Upper and Lower Connections of Side Frame of Single Side Bulk Carrier

Lloyd Register Asia
Yokohama Design Support Office
16 January 2008

Fig.3 (a) Shear Stress in Supporting Bracket at Longl Stiffener on Topside Sloping Bhd

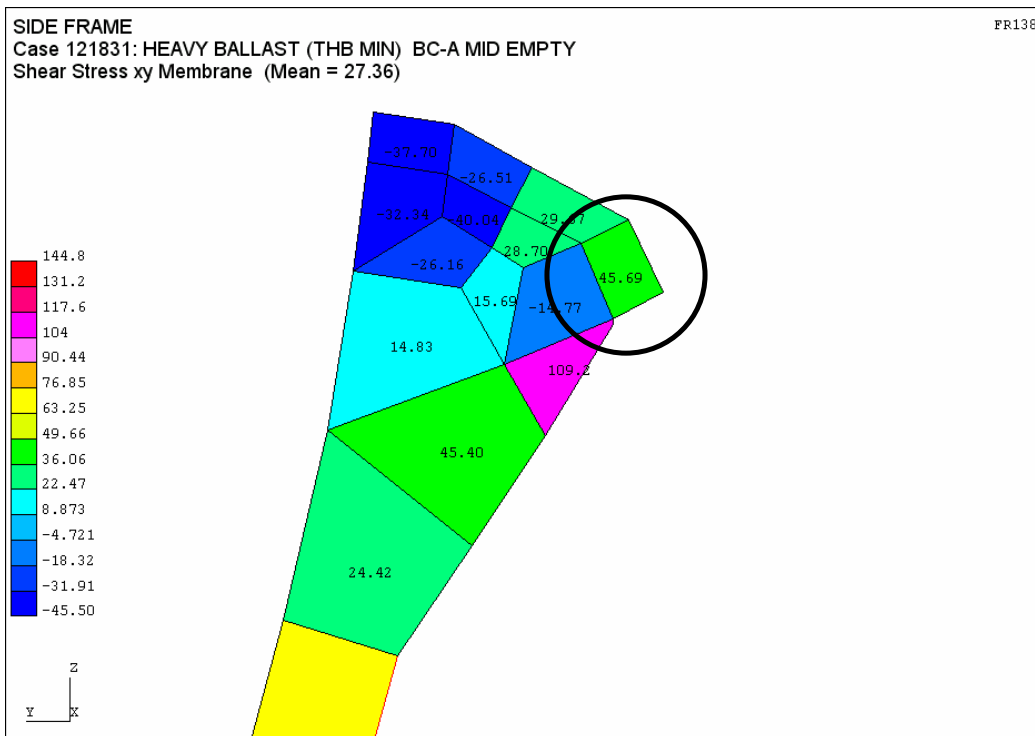
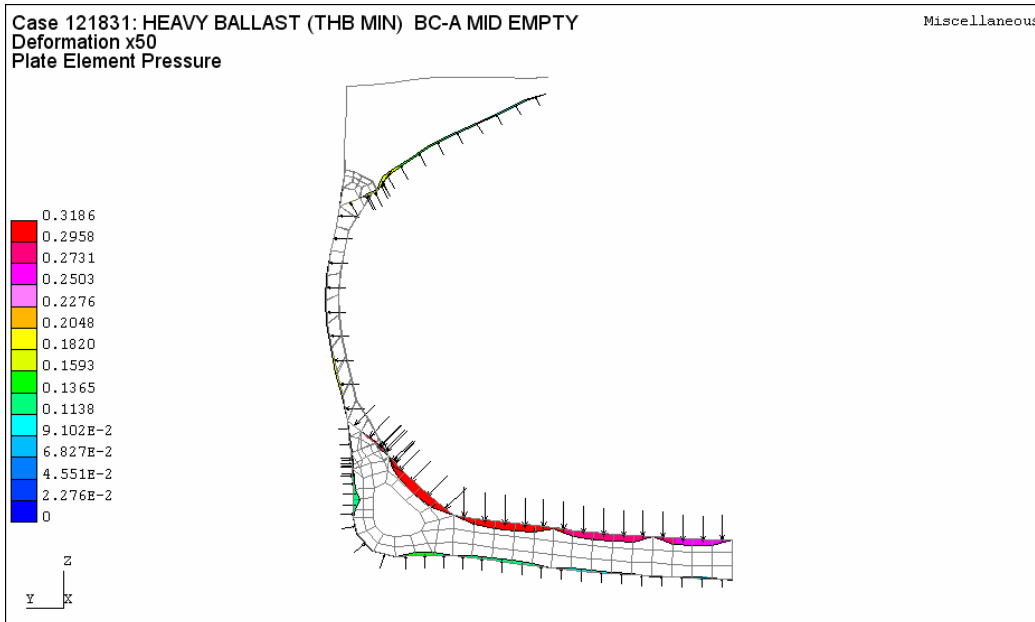
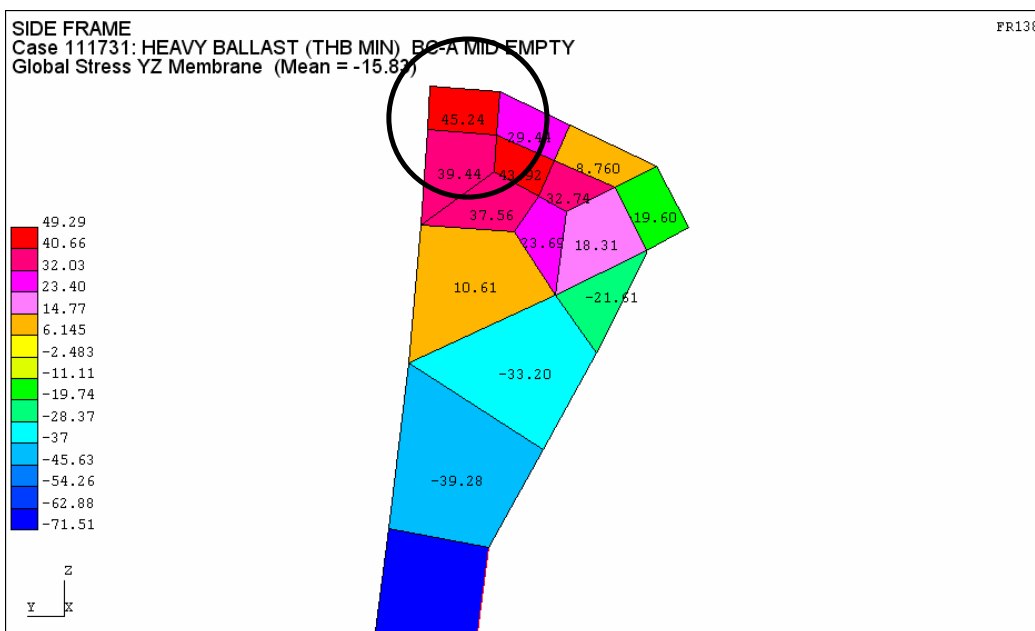
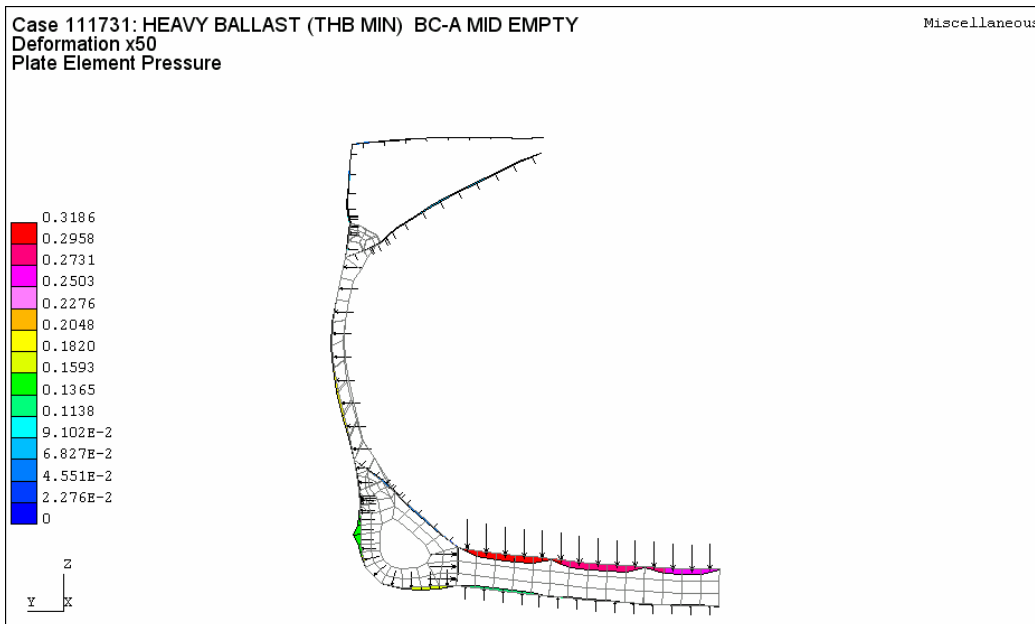
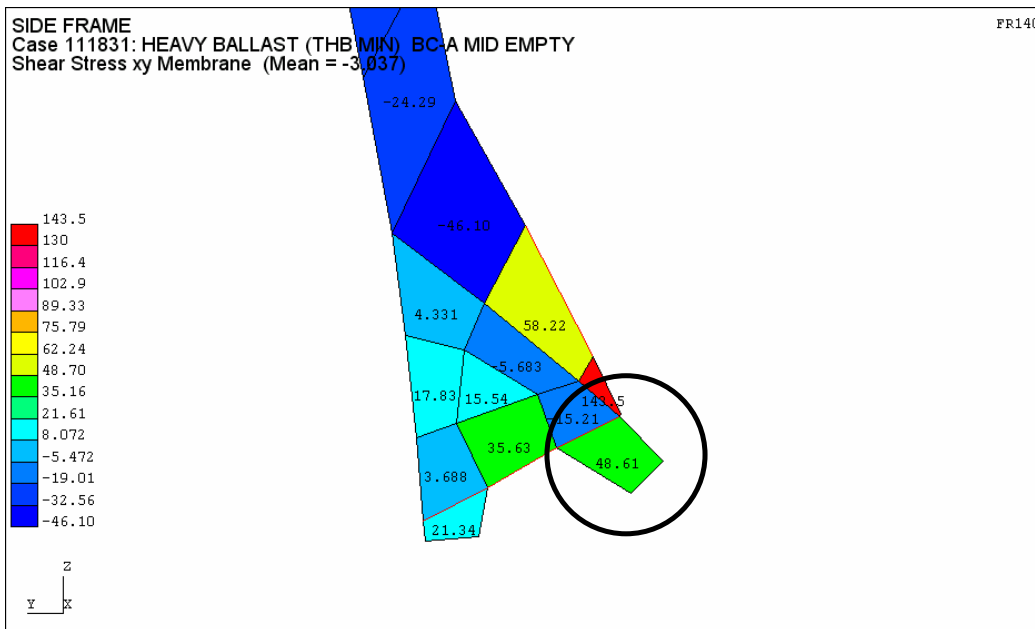
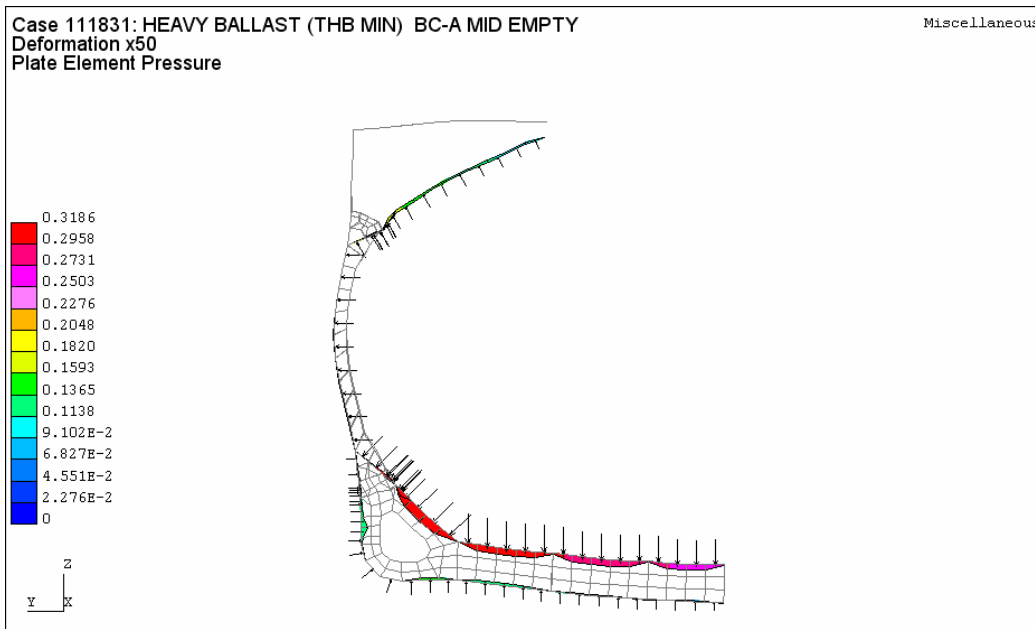
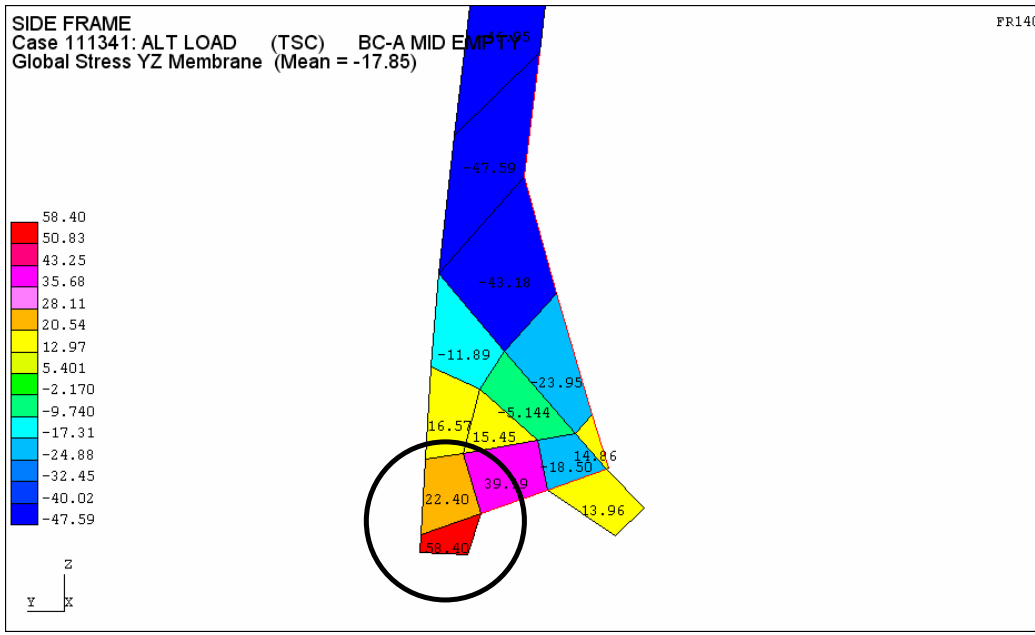
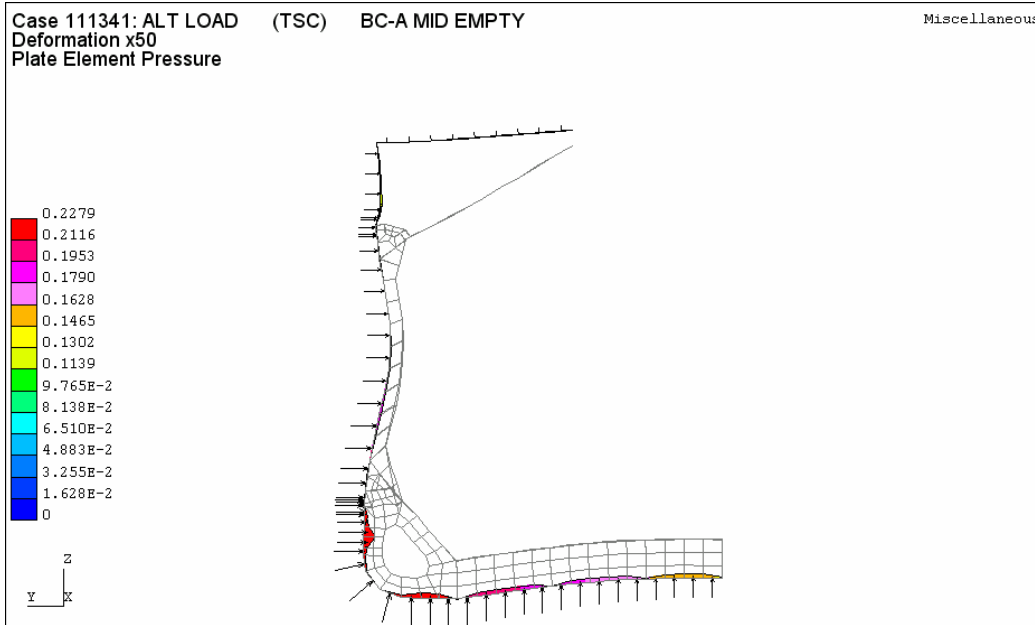
- 1.3.1 Maximum shear stresses in the supporting brackets have been calculated as follows;
 - 45.69 N/mm² at the longl stiffener on the topside sloping Bhd

- 45.24 N/mm² at the side shell longl in the topside tank
 - 48.61 N/mm² at the longl stiffener on the hopper side sloping Bhd
 - 58.40 N/mm² at the side shell longl in the hopper side tank

The shear stress values above are considerably small being compared with those anticipated in the requirement of Ch. 6, Sec. 2, Para. 3.4.2 of the Rules. There may be a possibility of the bracket net thickness required by the Rules

to be reduced. The theoretical background to the requirement should be reviewed taking this fact into account.

Fig.4 (a) Longl Stress in Longl Stiffener on Topside Sloping Bhd

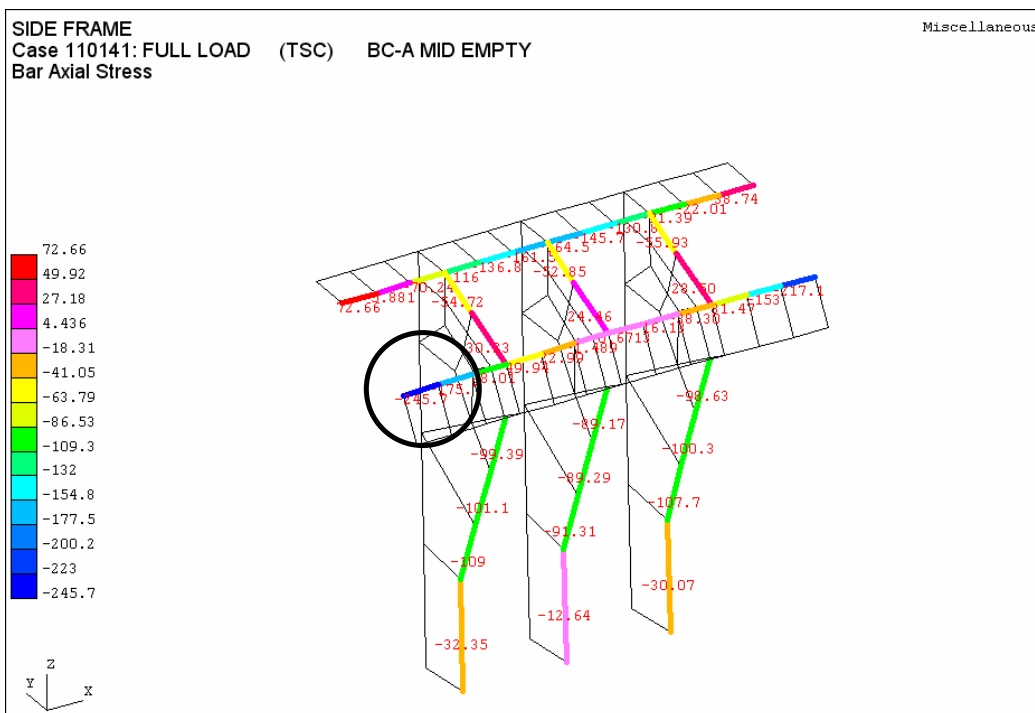
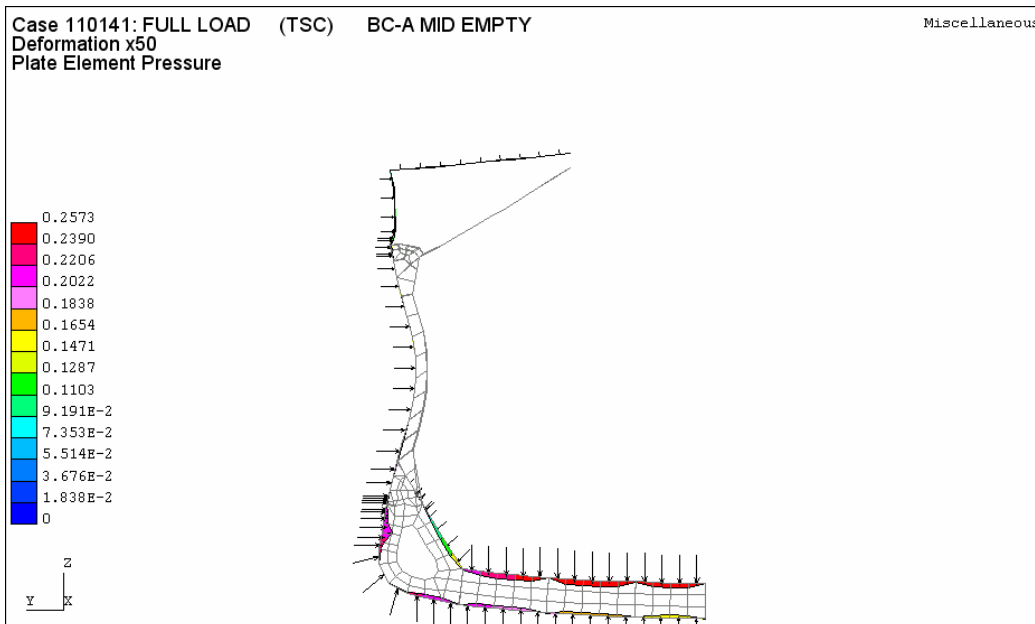
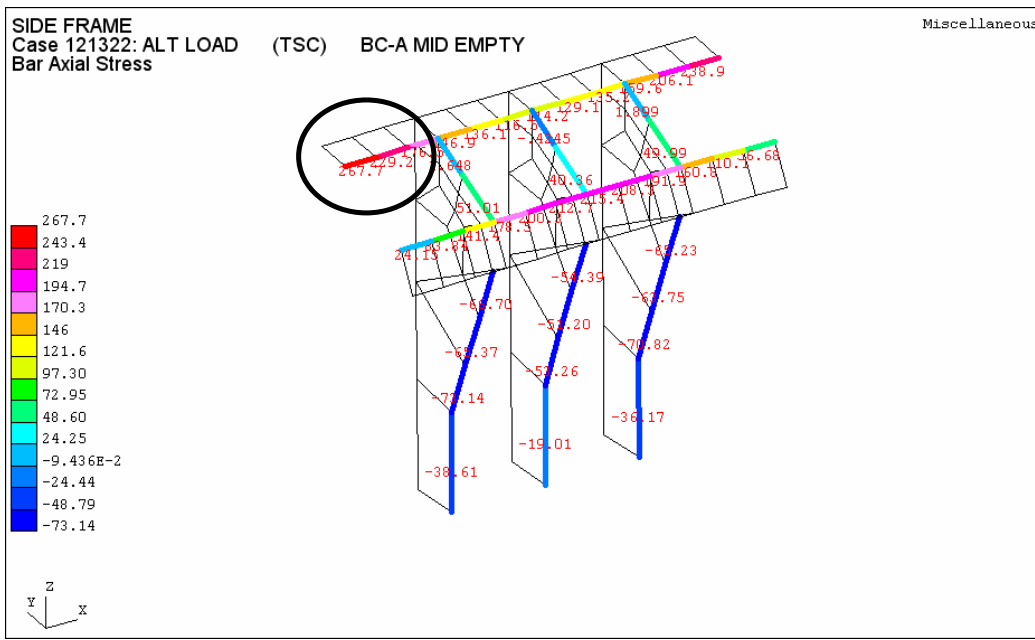
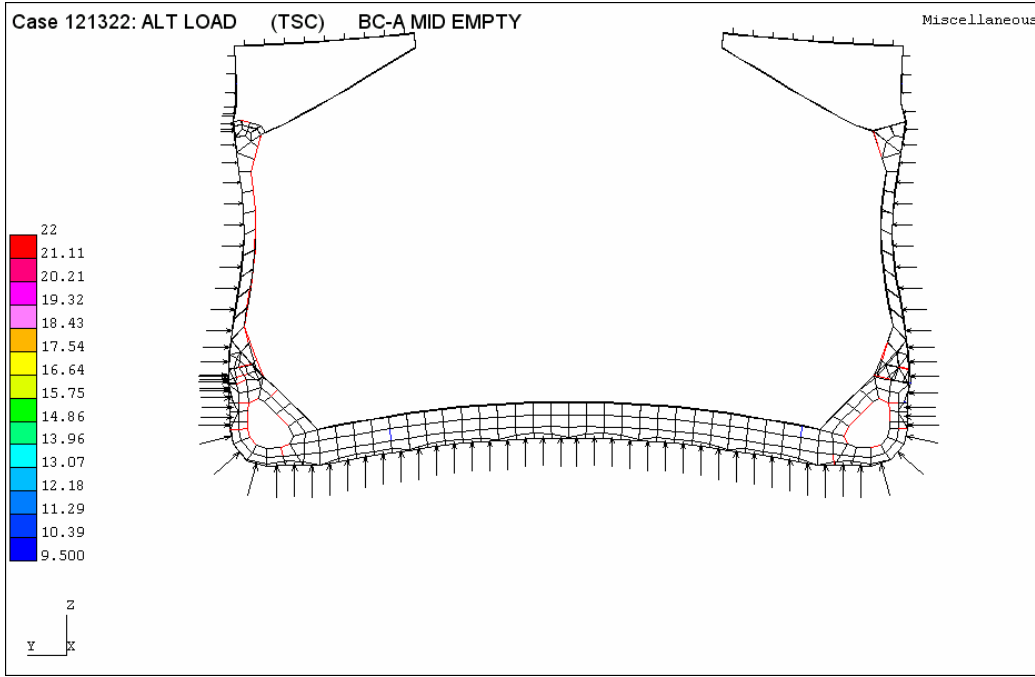
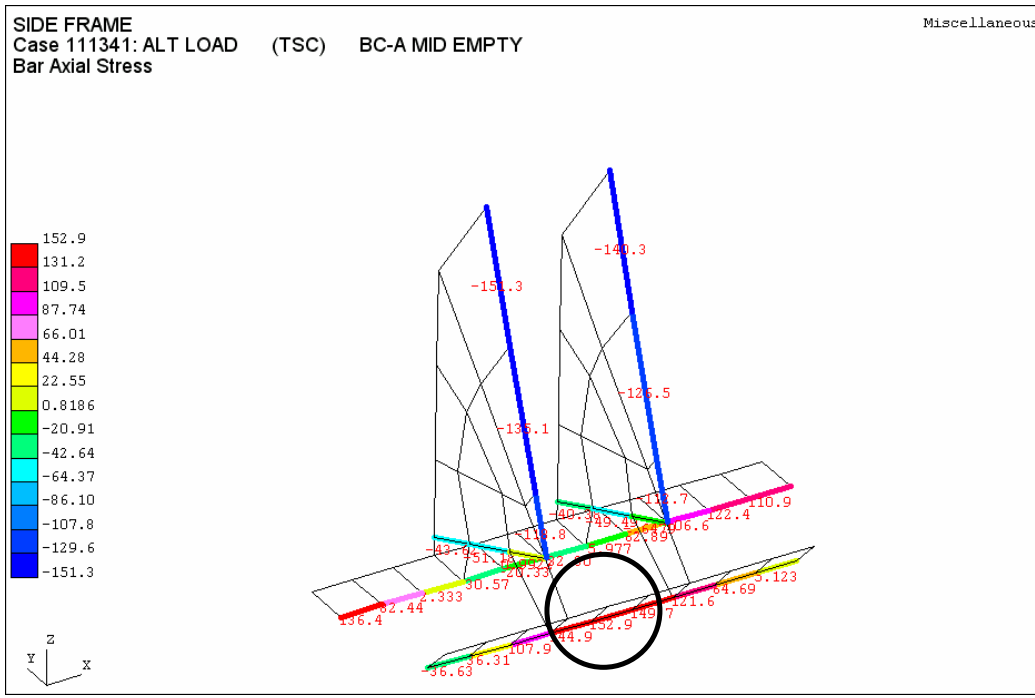
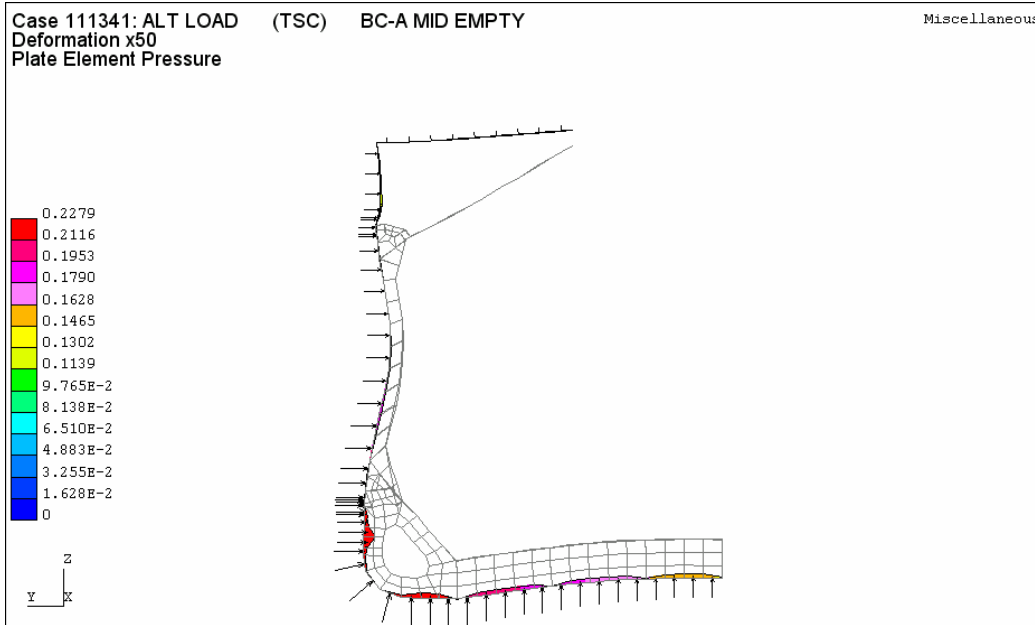
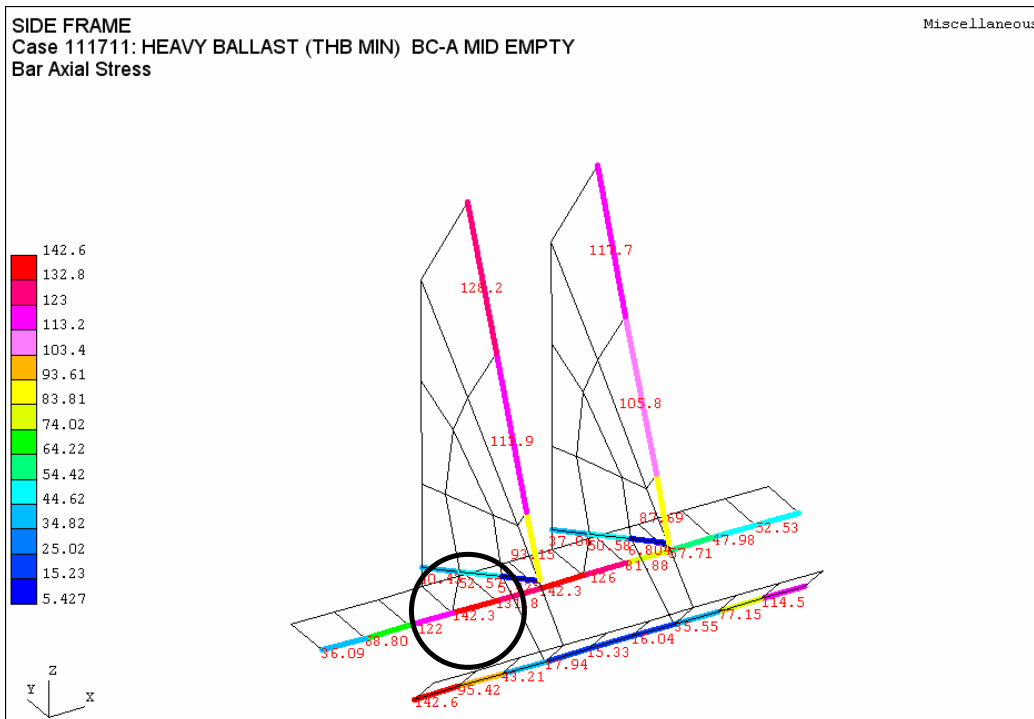
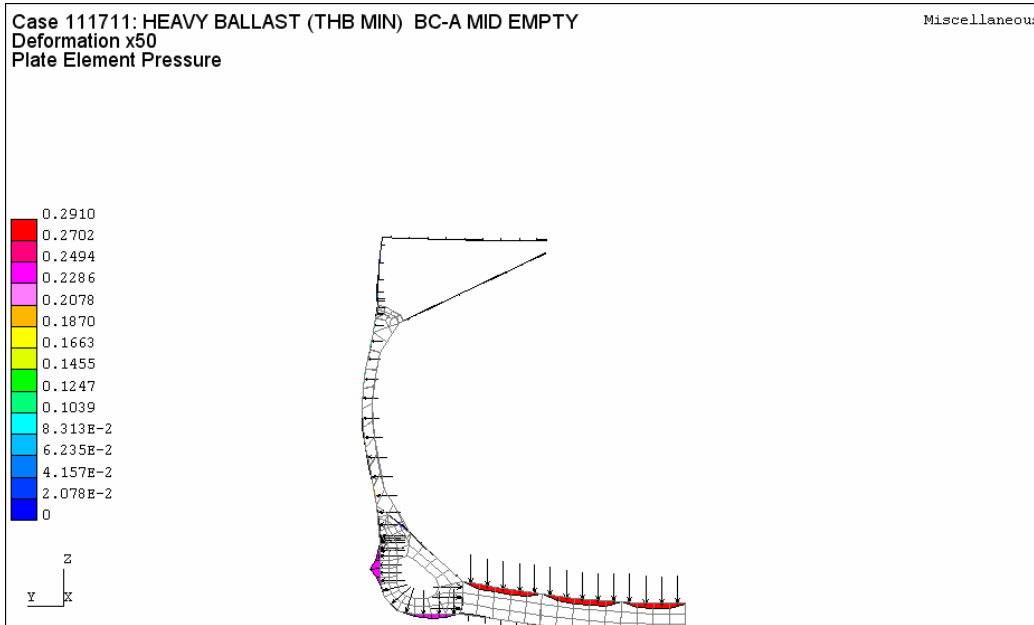
1.3.2 Maximum or minimum longl stresses in the longitudinal stiffeners have been calculated as follows;

- -245.7 N/mm² in the longl stiffener on the topside sloping Bhd
- 267.7 N/mm² in the side shell longl in the topside tank
- 152.9 N/mm² in the longl stiffener on the hopper sloping Bhd
- 142.6 N/mm² in the side shell longl in the hopper side tank

It should be noted that those values result in combination of the hull girder bending stress and the local bending stress by the shear loads at the supporting brackets. It is noted that the order of the stress values of the longl stiffeners in the hopper side tank are about half of that of the longl stiffeners in the topside tank.
